Proposed changes to Annex 120G

(possible response to comment #41)

Adam Healey

October 2020 (r2)

Suggested changes to 120G.5.2, page 241, line 23 (Alt. 1)

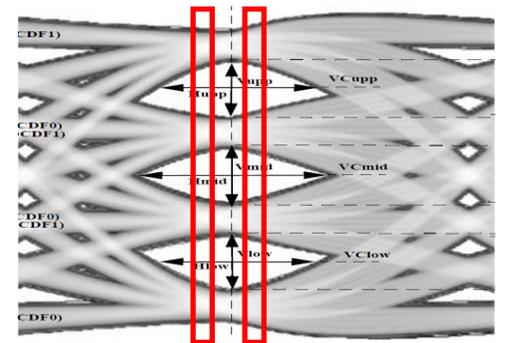
- Replace step h) with new steps h) through q) as shown below.
 - h) Define TCL to be $t_s - \text{TBD1 UI}$. Compute V_{mid} , V_{upp} , V_{low} , V_{Cmid} , V_{Cupp} , V_{Clow} from the eye diagram using 120E.4.2 steps 4) through 6) with the exception that the CDF of the signal voltage is accumulated over the time interval TCL \pm TBD2 UI and not “within 0.025 UI of time TCmid”. Label these values V_{Lmid} , V_{Lupp} , V_{Llow} , V_{CLmid} , V_{CLupp} , and V_{CLlow} respectively.

- i) Define TCR to be $t_s + \text{TBD1 UI}$. Compute V_{mid} , V_{upp} , V_{low} , V_{Cmid} , V_{Cupp} , V_{Clow} from the eye diagram using 120E.4.2 steps 4) through 6) with the exception that the CDF of the signal voltage is accumulated over the time interval TCR \pm TBD2 UI and not “within 0.025 UI of time TCmid”. Label these values V_{Rmid} , V_{Rupp} , V_{Rlow} , V_{CRmid} , V_{CRupp} , and V_{CRlow} respectively.

- j) Define V_{mid} to be $\min(V_{\text{Lmid}}, V_{\text{Rmid}}) - \text{abs}(V_{\text{CLmid}} - V_{\text{CRmid}})$
 - k) Define V_{upp} to be $\min(V_{\text{Lupp}}, V_{\text{Rupp}}) - \text{abs}(V_{\text{CLupp}} - V_{\text{CRupp}})$

- l) Define V_{low} to be $\min(V_{\text{Llow}}, V_{\text{Rlow}}) - \text{abs}(V_{\text{CLlow}} - V_{\text{CRlow}})$

“Alt. 1” continued

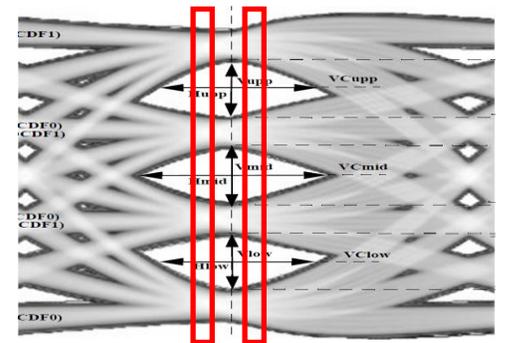
- m) Define VC_{mid} to be $(VCL_{mid} + VCR_{mid})/2$
- n) Define VC_{upp} to be $(VCL_{upp} + VCR_{upp})/2$
- o) Define VC_{low} to be $(VCL_{low} + VCR_{low})/2$
- p) The eye height is defined as the minimum of V_{mid} , V_{upp} , and V_{low} .
- q) Compute the vertical eye closure using Equation (120E–4) and the values computed in steps j) through o) with the exception that VM_3 , VM_2 , VM_1 , and VM_0 are the average values over the time interval $t_s \pm \text{TBD2 UI}$ and not “within 0.025 UI of time TC_{mid} ”.

Suggested changes to 120G.5.2, page 241, line 23 (Alt. 2)

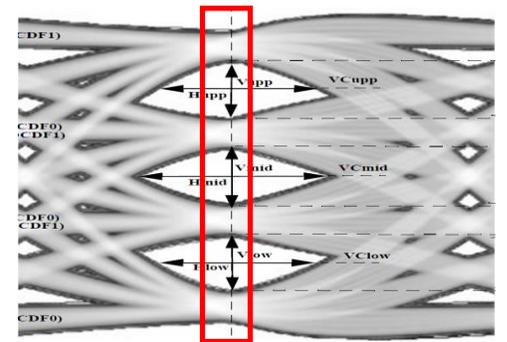
- Replace step h) with new steps h) through j) as shown below.
 - h) Compute V_{mid} , V_{upp} , V_{low} , V_{Cmid} , V_{Cupp} , V_{Clow} from the eye diagram using 120E.4.2 steps 4) through 6) with the exception that the CDF of the signal voltage is accumulated over the time interval $t_s \pm \text{TBD UI}$ and not “within 0.025 UI of time T_{Cmid} ”.
 - i) The eye height is the minimum of V_{mid} , V_{upp} , and V_{low} .
 - j) Compute the vertical eye closure using Equation (120E–4) and the values computed in step h) with the exception that $VM3$, $VM2$, $VM1$, and $VM0$ are the average values over the time interval $t_s \pm \text{TBD UI}$ and not “within 0.025 UI of time T_{Cmid} ”.

Suggested changes to 120G.3.4.1.1

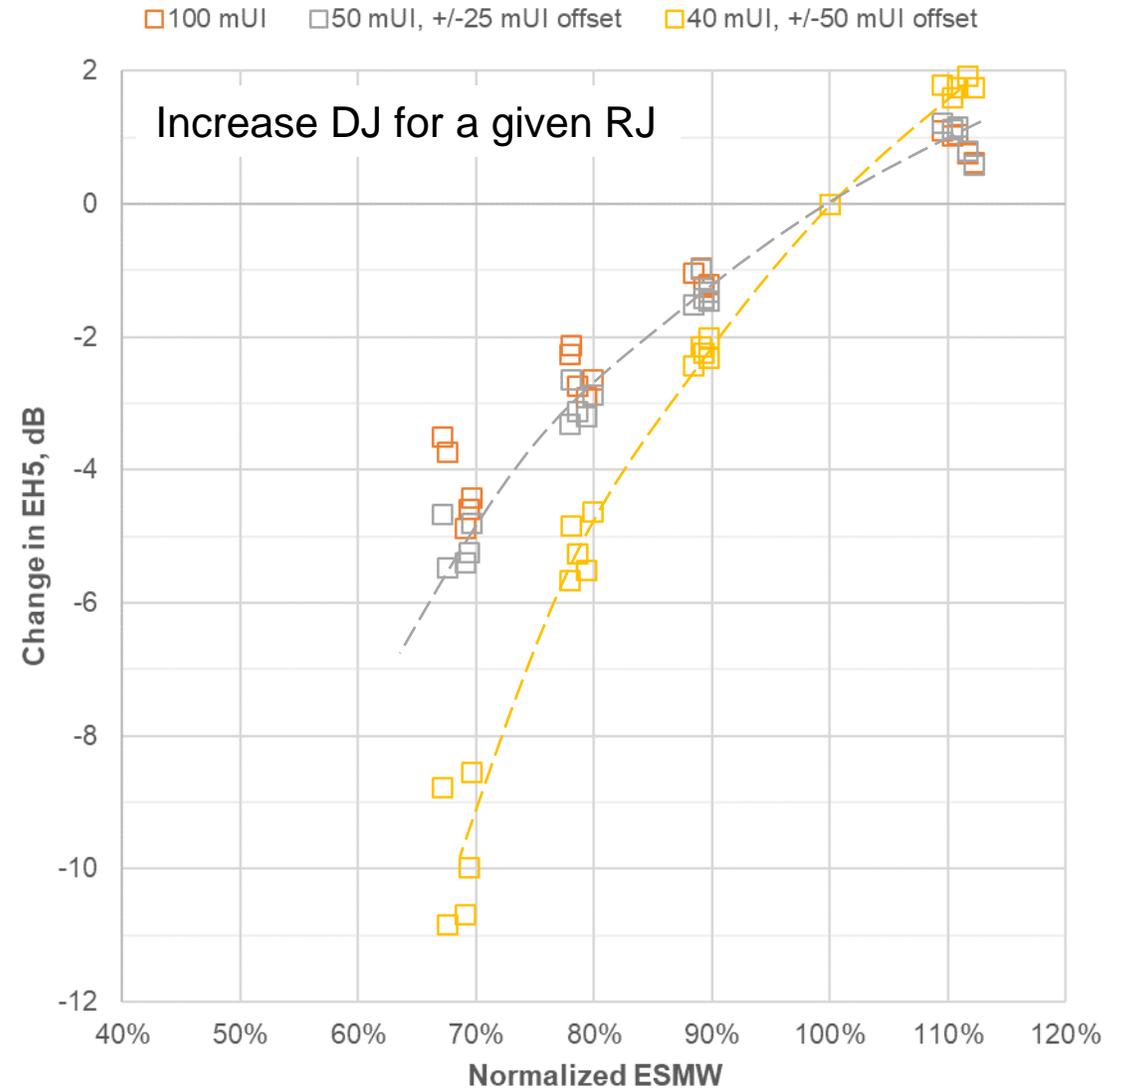
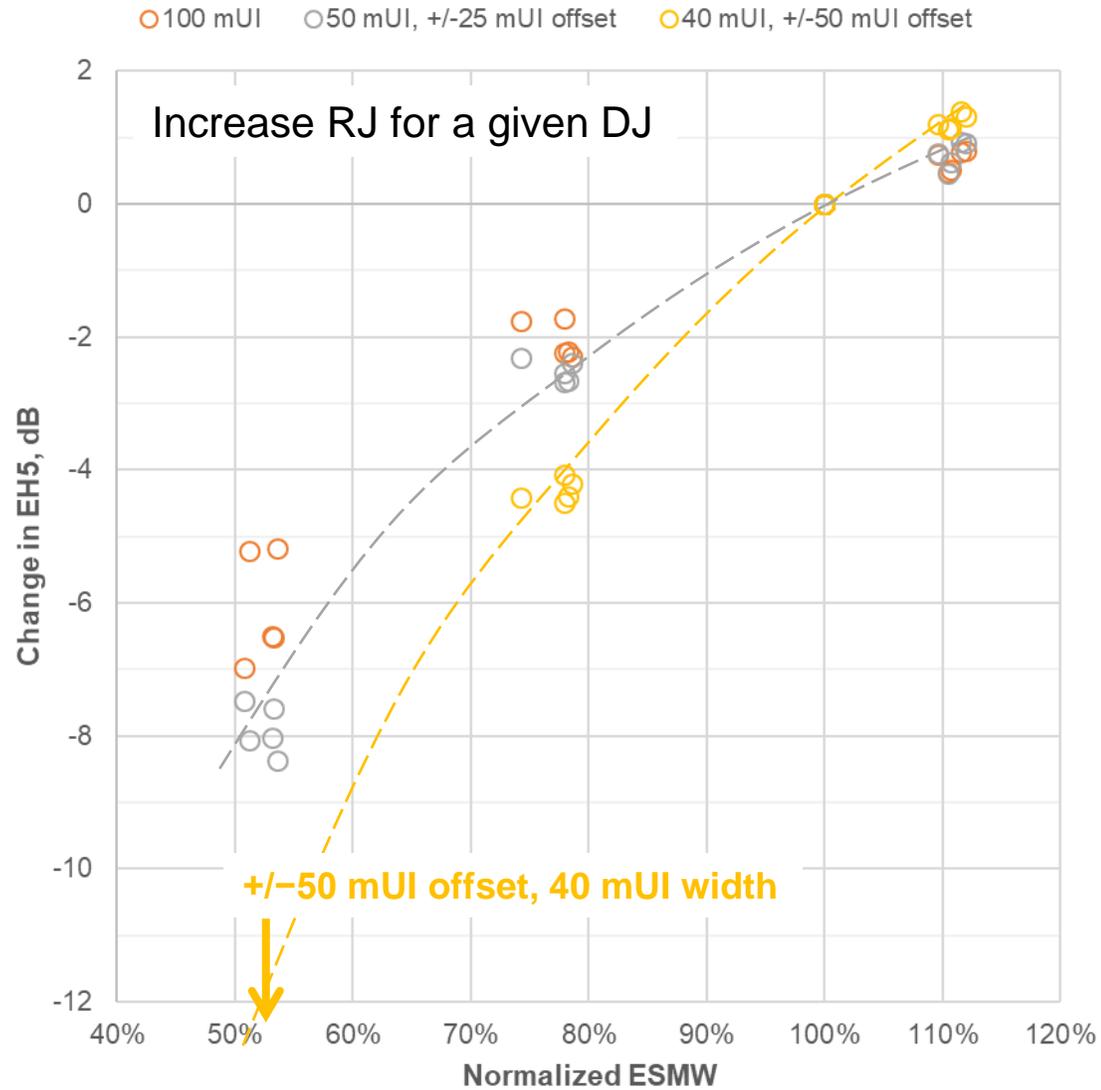
- Page 237, line 12
... to result in the eye height for all three eyes ~~and eye width for the smallest eye~~ given in Figure 120G–9
- Page 237, line 13
... using the reference receiver with the setting that ~~maximizes the product of eye height and eye width~~ minimizes the vertical eye closure.
- Page 237, line 17
Eye height ~~and eye width~~ at TP1a ~~are~~is then adjusted in the same way as described for the high-loss case except that ...
- Table 120G–9—Module stressed input parameters
Remove “Far-end eye width” row
